SIB 21 01 21

INDIVIDUAL CLUTCH PARTS UNAVAILABLE

2021-03-19

**BMW
MOTORRAD**

Figure 1: Previous Build Level

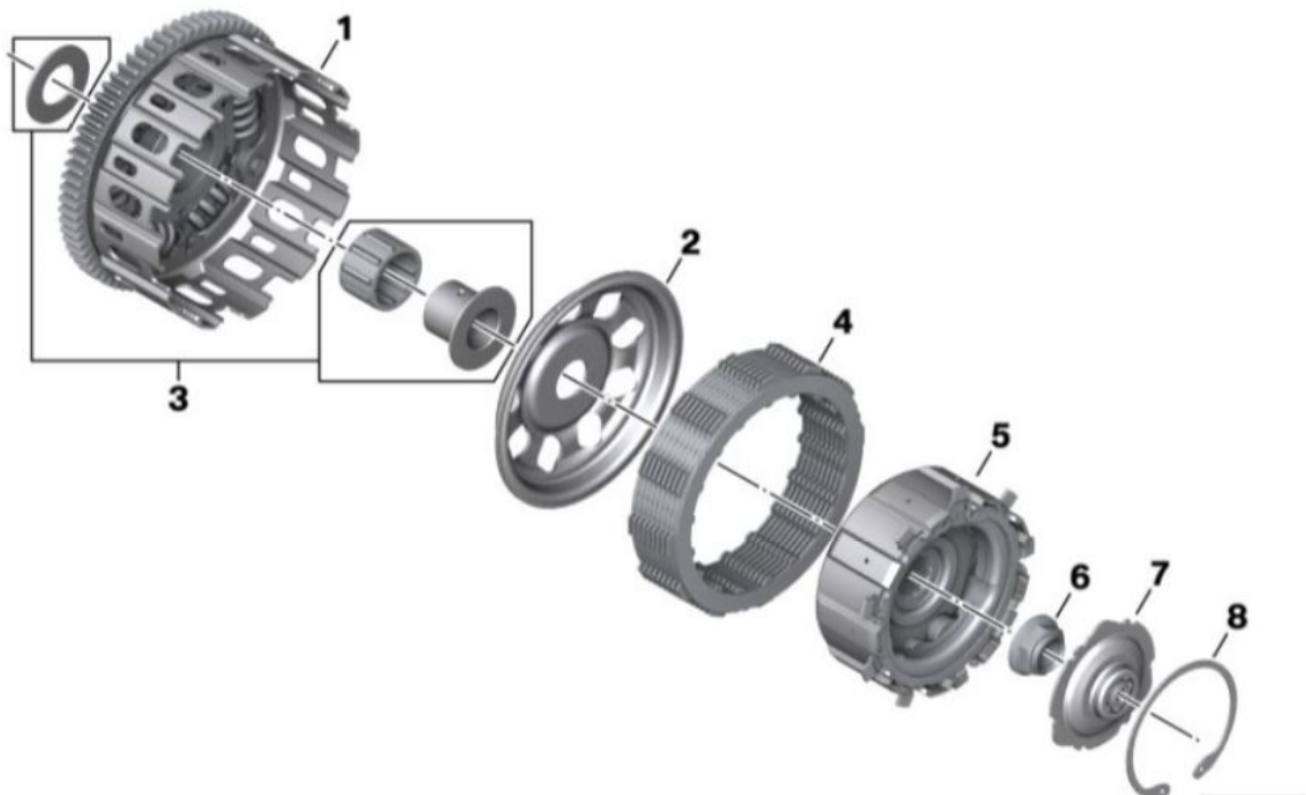
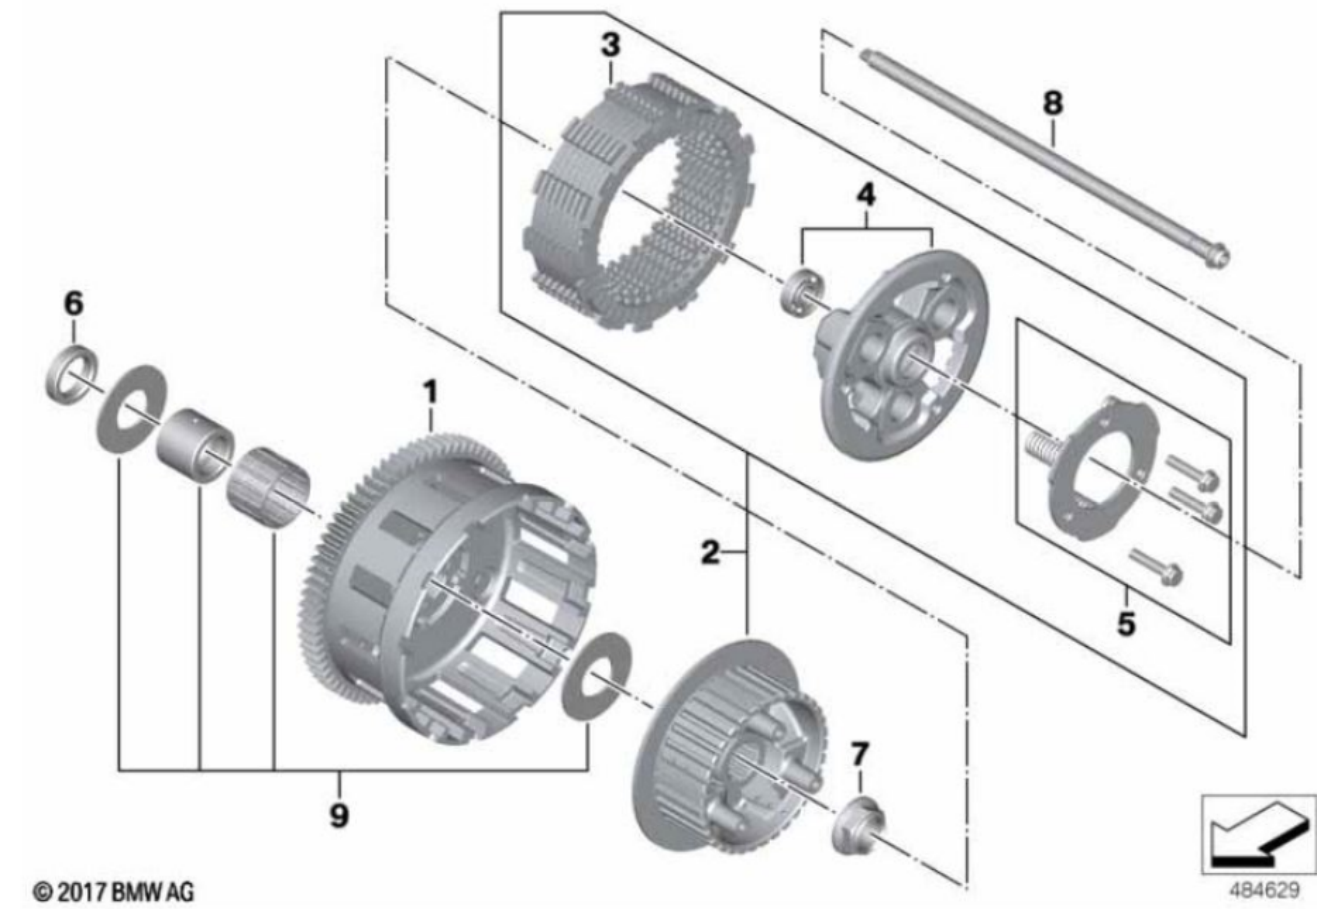
For K83, K84, produced up to August 2020, no individual replacement parts will be offered for the clutch; see image "Figure 1: Previous Build Level", below.

For vehicles produced since August 2020, a new build level of the clutch is installed (analogous to K80, K81, K82) in the standard and replacement engines, see "Figure 2: Current Build Level", below.

If necessary, motorcycles produced prior to August 2020 should have their clutch updated to the newer version.

The new clutch to be installed, part number 21 21 8 565 058, is identical to the clutch in models K80/K81/K82. The new clutch is installed according to the installation instructions for a K80/K81/K82 or K83/K84 (build level from August 2020) clutch under "Remove/install or replace clutch". Take note of any special tools you may need.

Figure 1: Previous Build Level

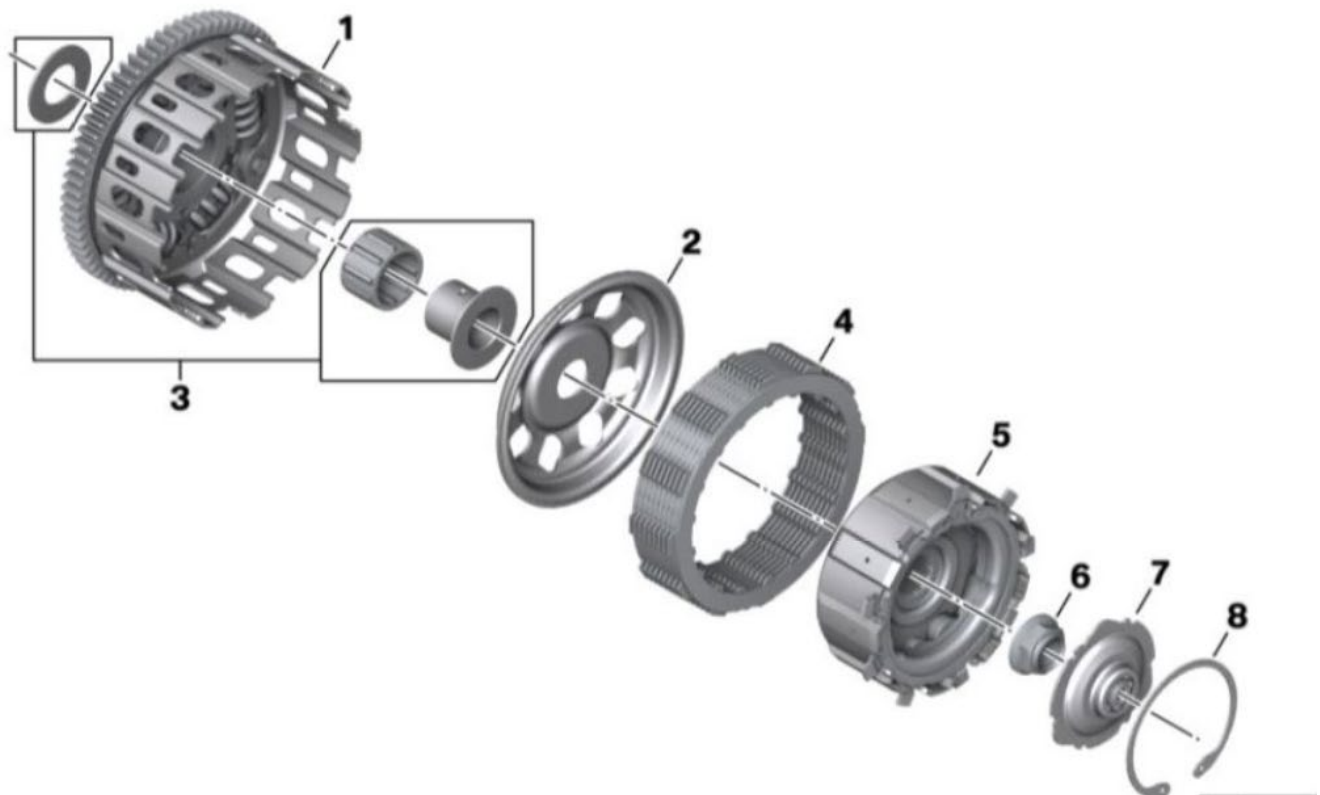
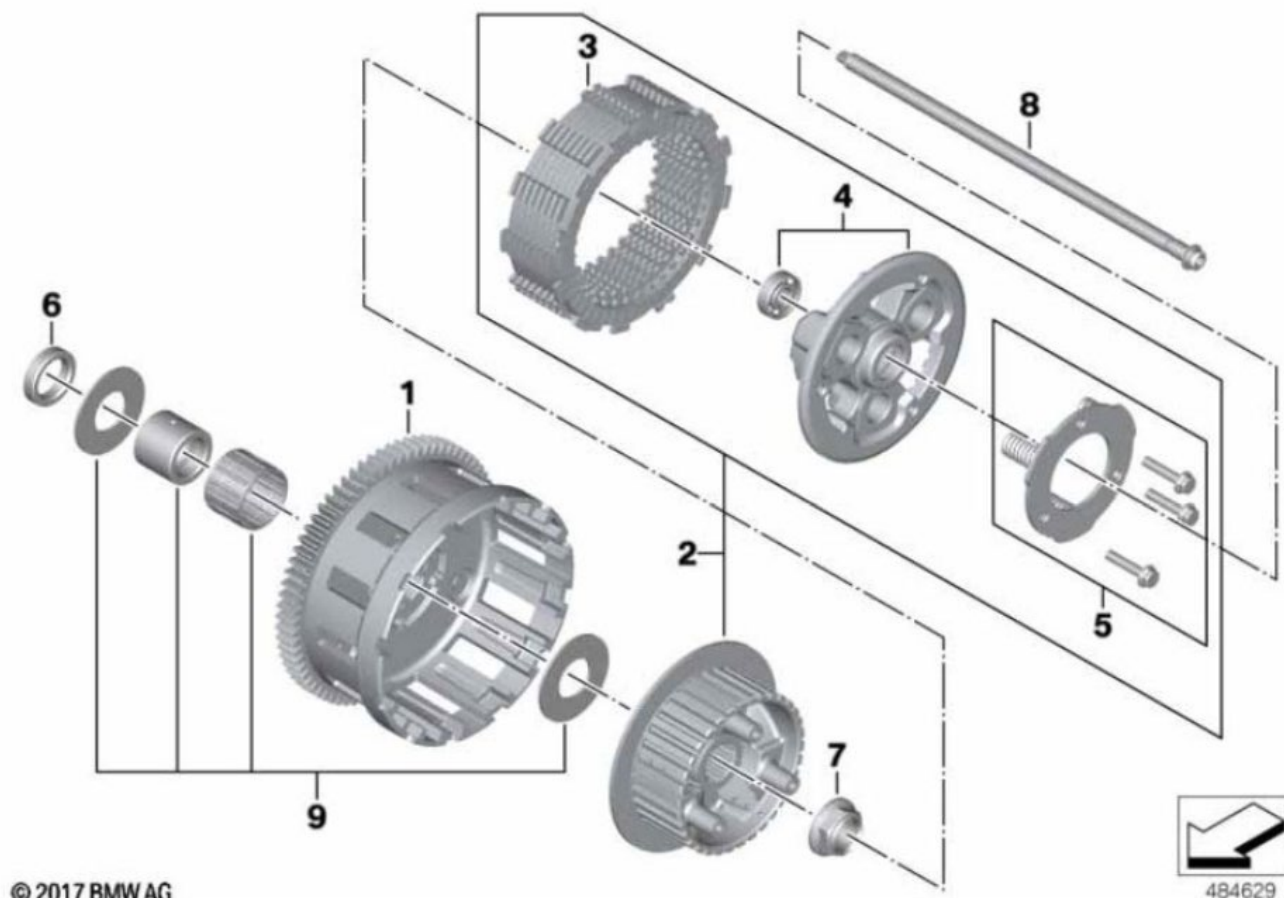
For K83, K84, produced up to August 2020, no individual replacement parts will be offered for the clutch; see image "Figure 1: Previous Build Level", below.

For vehicles produced since August 2020, a new build level of the clutch is installed (analogous to K80, K81, K82) in the standard and replacement engines, see "Figure 2: Current Build Level", below.

If necessary, motorcycles produced prior to August 2020 should have their clutch updated to the newer version.

The new clutch to be installed, part number 21 21 8 565 058, is identical to the clutch in models K80/K81/K82. The new clutch is installed according to the installation instructions for a K80/K81/K82 or K83/K84 (build level from August 2020) clutch under "Remove/install or replace clutch". Take note of any special tools you may need.
